New Jersey Turnpike Authority

Document Change Announcement

Electrical Qualification Criteria Updates

DCA2024DM-01

Exhibit 8-18 Exhibit 8-16 Lighting Standard Designation Method

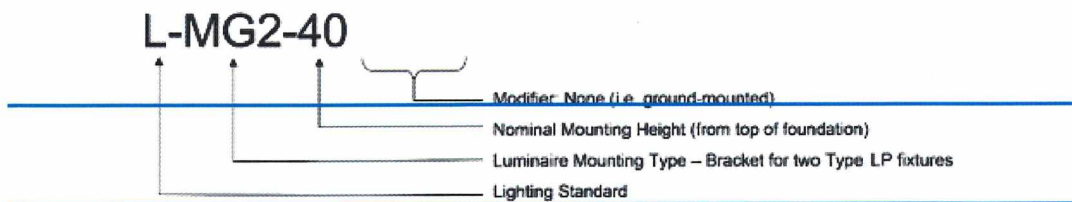
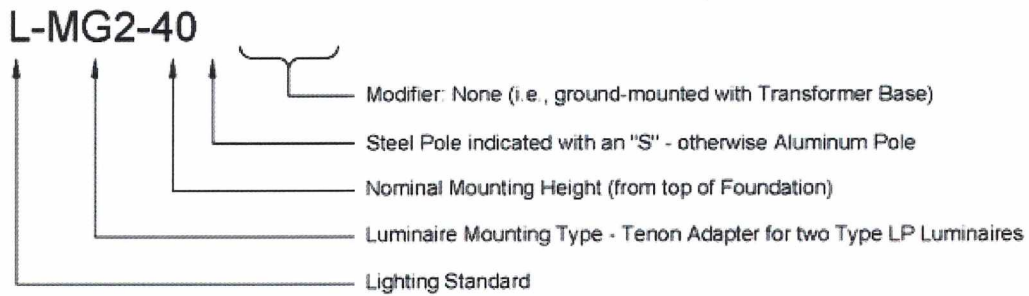
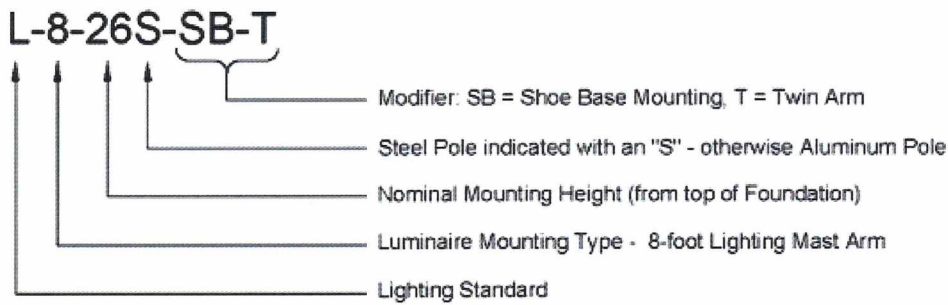
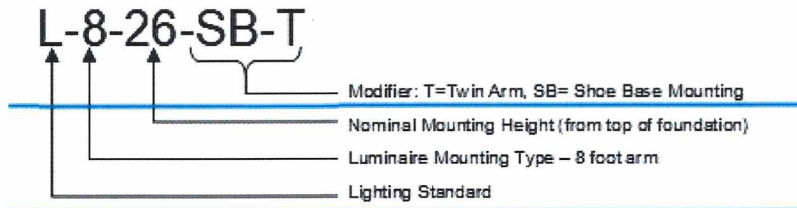
Legacy light poles shall be considered non-standard. Legacy and other non-standard poles are approved for use by the Authority according to other requirements in this Section, the poles shall be designated with the Modifier "NS1", "NS2", etc. for each type of non-standard pole used on a project. The details and model number information for all non-standard poles shall be clearly shown in the Plans. For example, a painted steel Architectural parking lot lighting pole with 20-foot height and 4-foot arm would be designated "L-4-20-NS1." A pole of the same construction, but with 25-foot height would be "L-4-25-NS1". A twin arm pole would be "L-4-25-NS1-T", etc.

Exhibit 8-19 ~~Exhibit 8-17~~ Typical Roadway Lighting Standard Arrangements

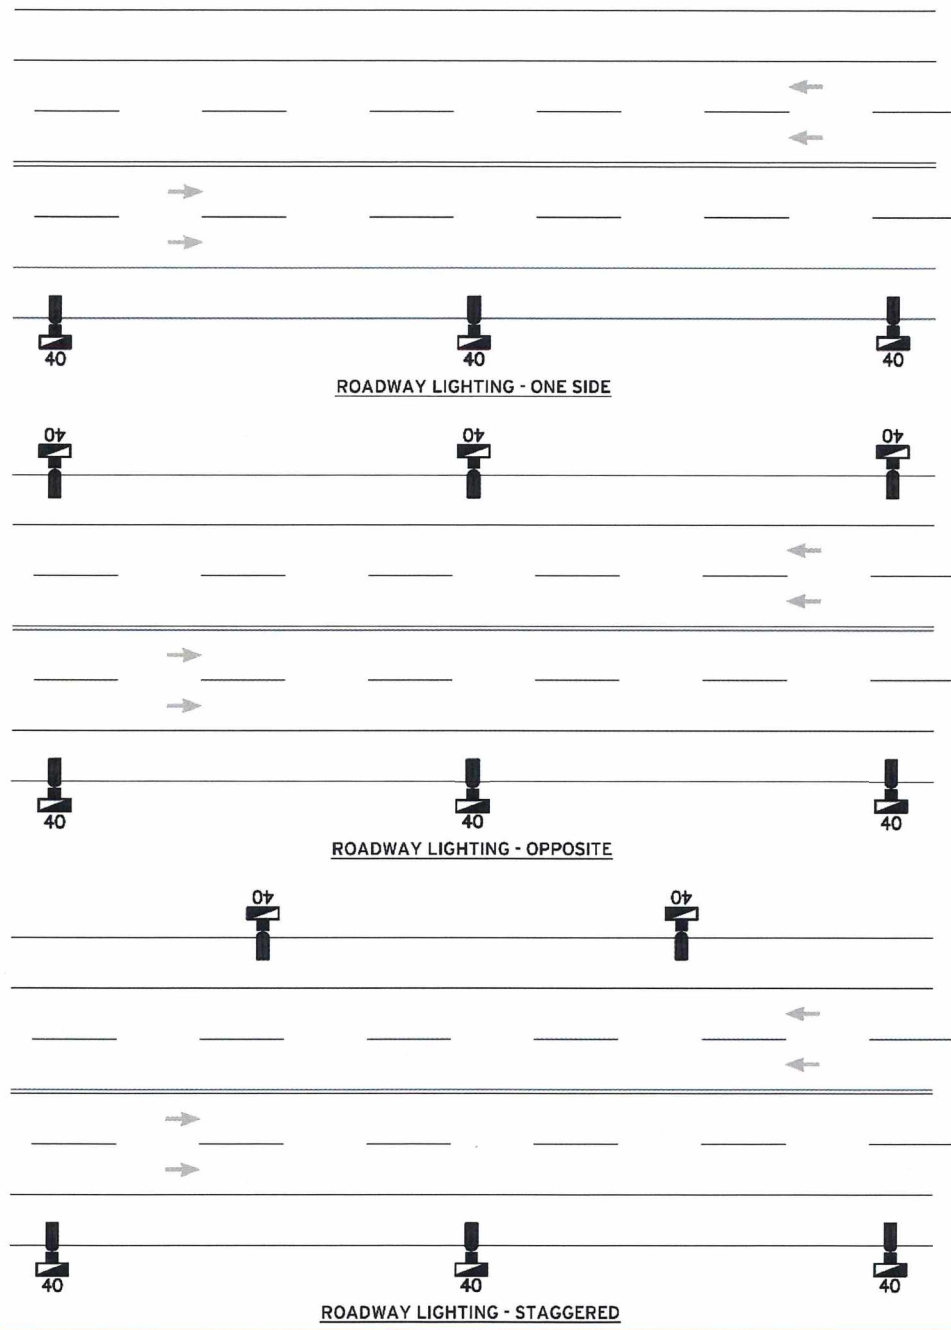
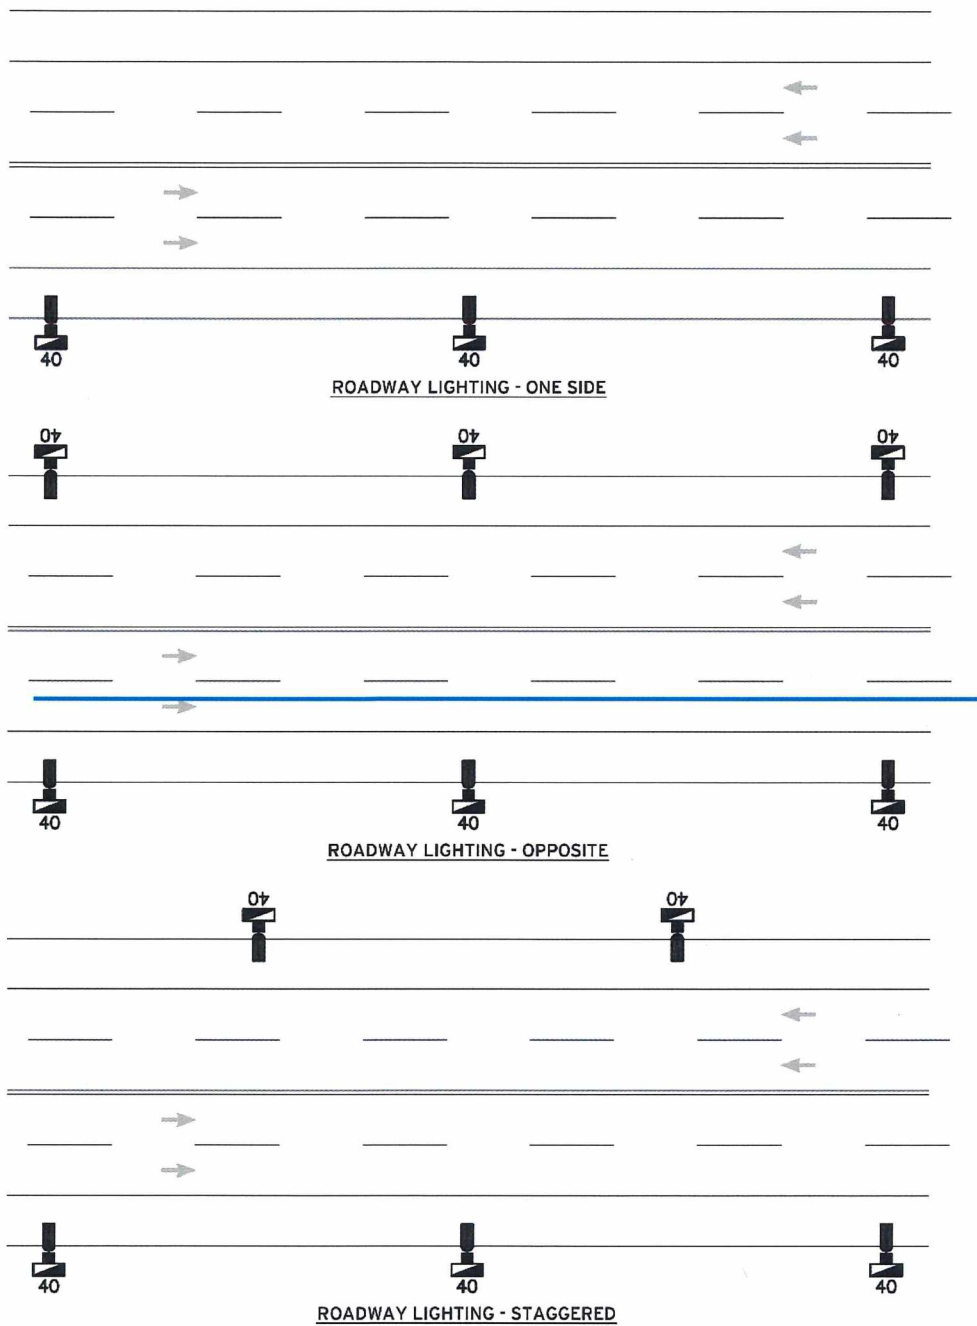
2. Lighting standards shall be arranged in one of the following three (3) methods; one-sided, opposite, staggered. Installation of Lighting Standard on a median barrier shall require prior approval by the Authority. An illustration of these arrangements follows in Exhibit 8-19. Selection of the method shall be based on the engineering analyses shown to produce the most effective and economical lighting system. The Engineer shall analyze both installation methods to determine the recommended scenario and shall describe the analysis as part of the submission report. Except where non-symmetrical geometry is encountered, lighting shall be evenly spaced and staggered to yield a pleasing visual appearance. See Subsection 8.2.5 for more information regarding aesthetic treatment of lighting installations.

~~Lighting standards shall be arranged in one of the following three (3) methods; one sided, opposite, staggered. Installation of Lighting Standard on a median barrier shall require prior approval by the Authority. An illustration of these arrangements follows in Exhibit 8-19. Selection of the method shall be based on the engineering analyses shown to produce the most effective and economical lighting system. The Engineer shall analyze both installation methods to determine the recommended scenario and shall describe the analysis as part of the submission report. Except where non-symmetrical geometry is encountered, lighting shall be evenly spaced and staggered to yield a pleasing visual appearance. See Subsection 8.2.5 for more information regarding aesthetic treatment of lighting installations.~~

~~Exhibit 8-17 Typical Roadway Lighting Standard Arrangements~~
